TECHNICAL ANALYSIS

HIAWATHA MINES COMPLEX

Figure 9
 HIAWATHA MINES COMPLEX

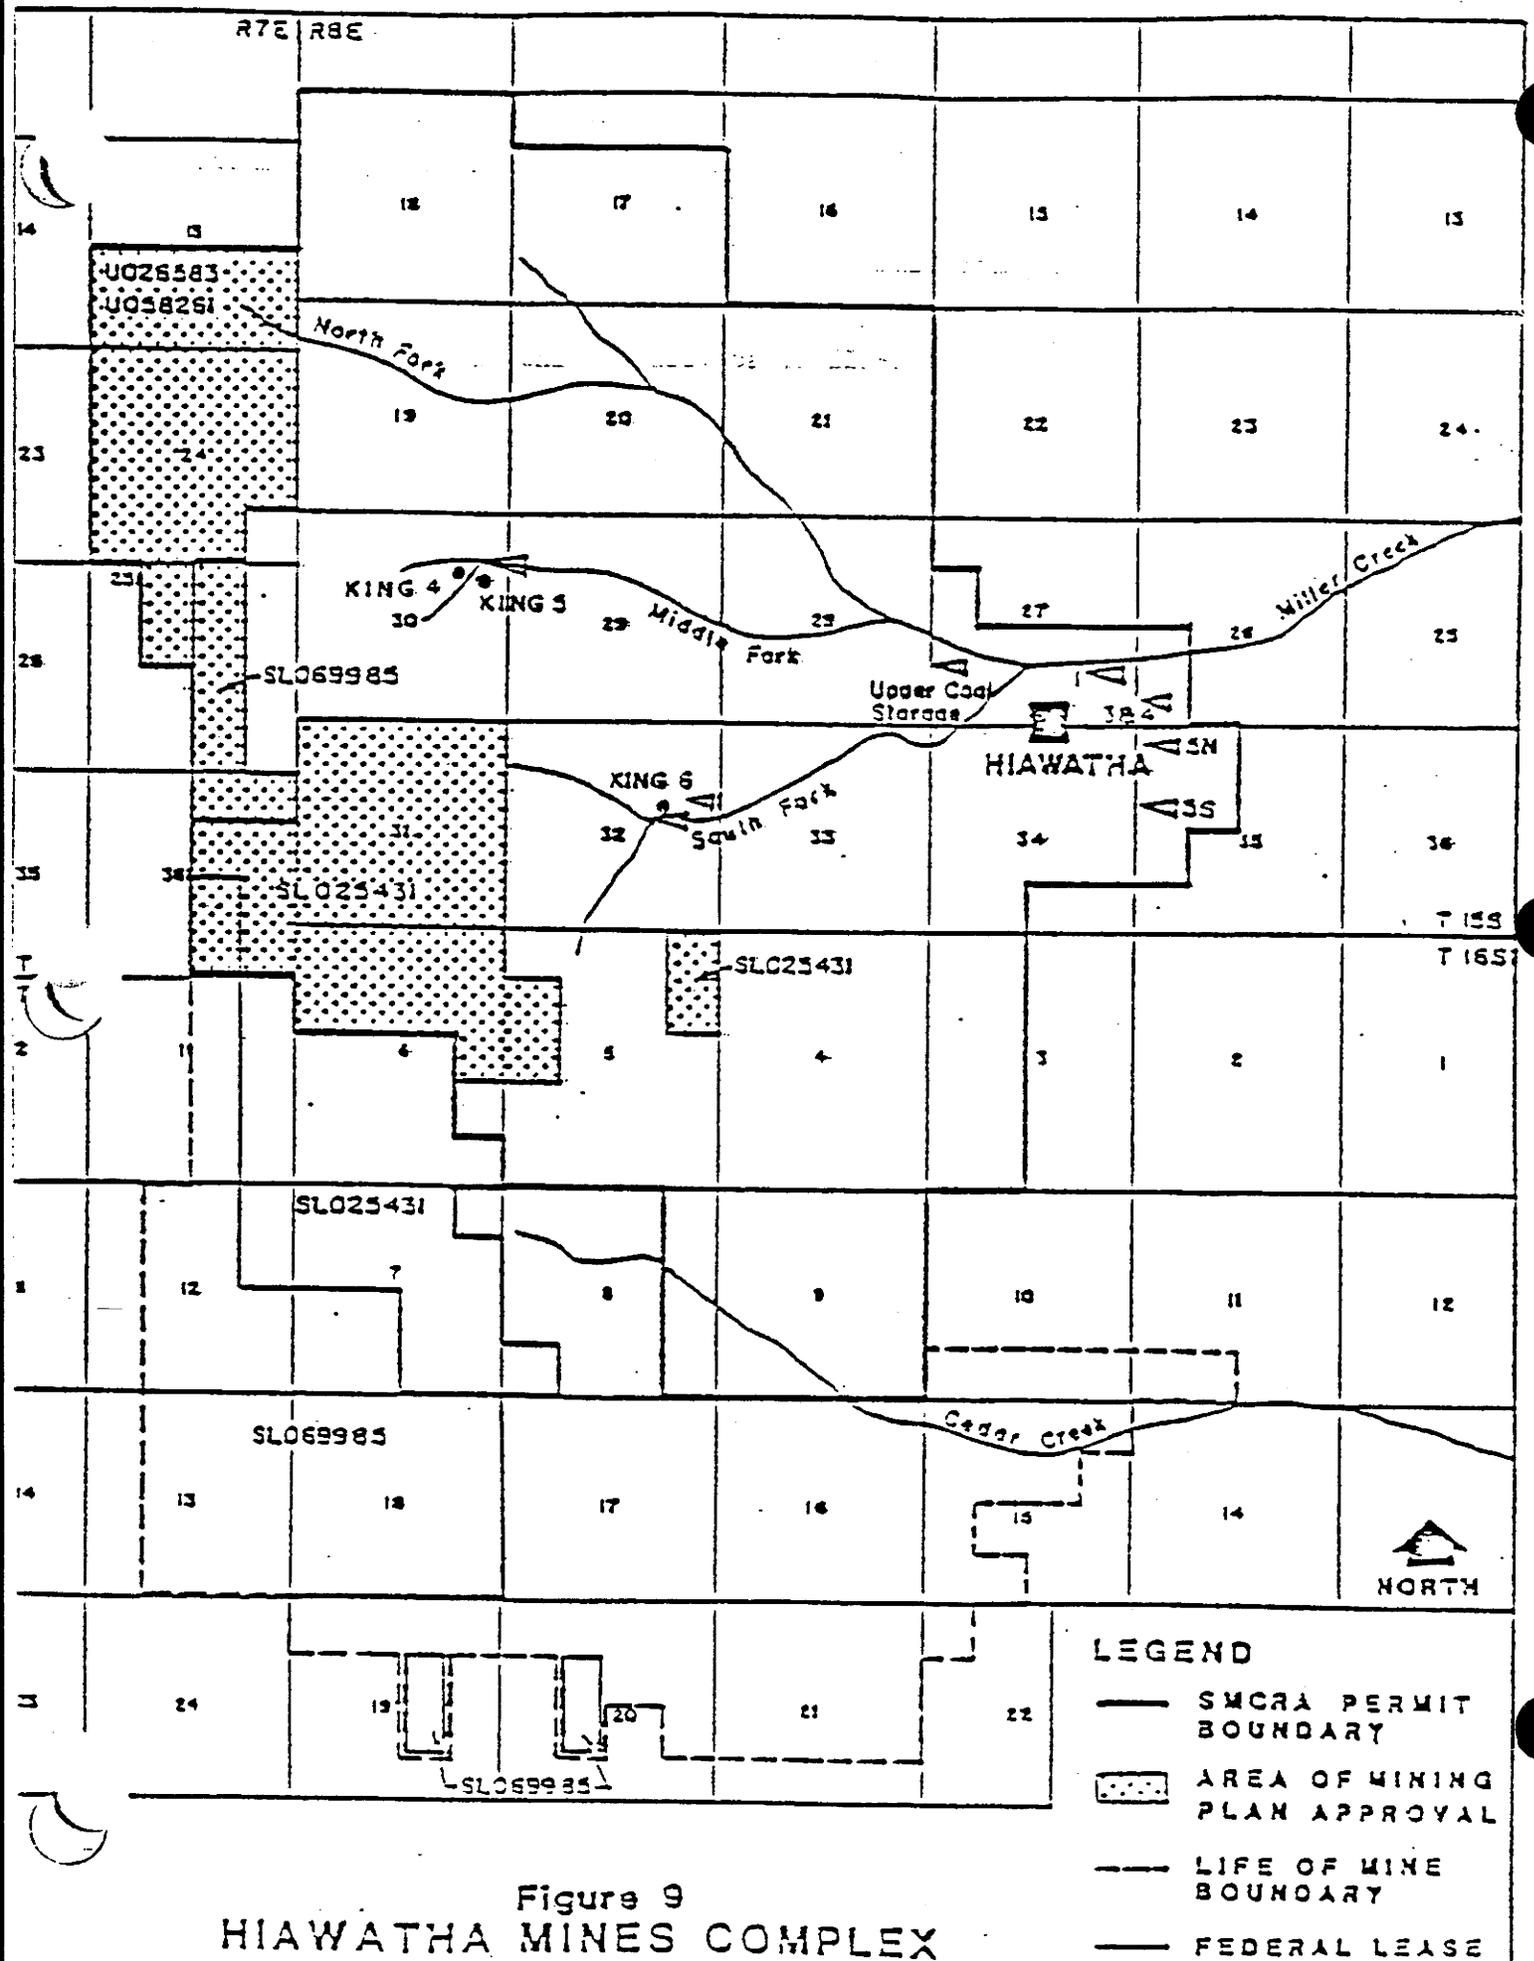
The Hiawatha Mines Complex currently contains eight sedimentation ponds (see Figure 9). Most of these ponds were constructed in 1978 or 1979 to achieve on-the-ground compliance with the drainage and sediment control rules and regulations of OSM's interim regulatory program. Approval of the sedimentation ponds for the Middle Fork portal yard, South Fork portal yard, and upper coal storage yard was given by OSM and UDOGM on May 30, 1980. Approval of the ponds was given by Utah Water Pollution Control Board in August 1979. The sediment control structures for the coal pile/truck loadout area on the South Fork were reviewed by OSM and UDOGM during the analysis in conjunction with the reopening of King No. 6 Mine (approved July 15, 1981). Review and approval of the other sedimentation ponds were deferred for later review. U.S. Fuel also proposes using three sedimentation ponds to control sediment from the postmining topsoil borrow areas (A, B, C, and D).

complexity of these modifications, it has become increasingly difficult to identify the on-the-ground sediment control plan in the PAP. To aid inspectors and future reviewers, and to comply with the appropriate regulation, condition No. 3 is necessary.

Therefore, the only available storage is the 6.2 acre-feet of active storage. This storage volume is sufficient for runoff from the disturbed area and wastewater from the processing plant, but not enough to contain the design event from the undisturbed areas. Therefore, Condition No. 4 is necessary for future long-term use of Slurry Pond 5A. U.S. Fuel is not currently using Slurry Pond 5A.

The applicant has constructed a small (about 1 acre) ventilation pad on the right fork of the North Fork of Miller Creek. (See Figure 9.) Because of the small area of disturbance, a small area exemption was allowed (UMC 817.42 (a)(3)), and the applicant is using straw bales to control sediment from the area. This is in compliance with UMC 817.42 and 817.45.

Within sixty (60) days of the effective date of this permit, the permittee must submit to the regulatory authority a revised plan demonstrating adequate runoff storage for Slurry Pond 5A. Slurry Pond 5A is not to be used to contain runoff from the undisturbed areas flowing through culverts Nos. 2 and 12 until a revised plan is submitted and approved by the regulatory authority.
